Product Change Notification

Change Notification #: 111556 - 00
Change Title: Intel® Chipsets Carrier Tape Change for 34x34mm Tape and Reel Packed Products, PCN 111556-00, Transport Media
Date of Publication: June 12, 2012

Key Characteristics of the Change:

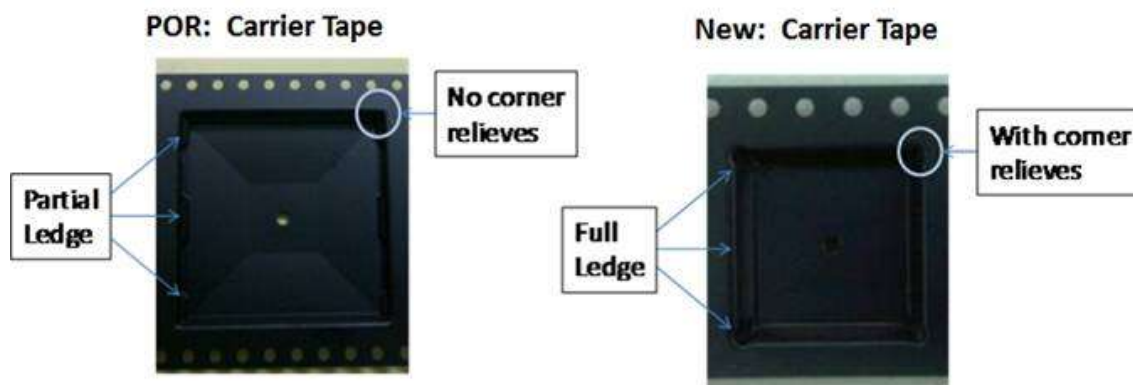
Intel will be replacing our current supplier of carrier tapes for tape and reel packed products. The new carrier tape design has full peripheral ledge supports as well as smaller pocket corner relief openings. All Critical-to-Function dimensions are the same. Since both the old and new carrier tapes have the same form factor, they are allowed to be mixed in a shipment as they are transparent in terms of functionality.
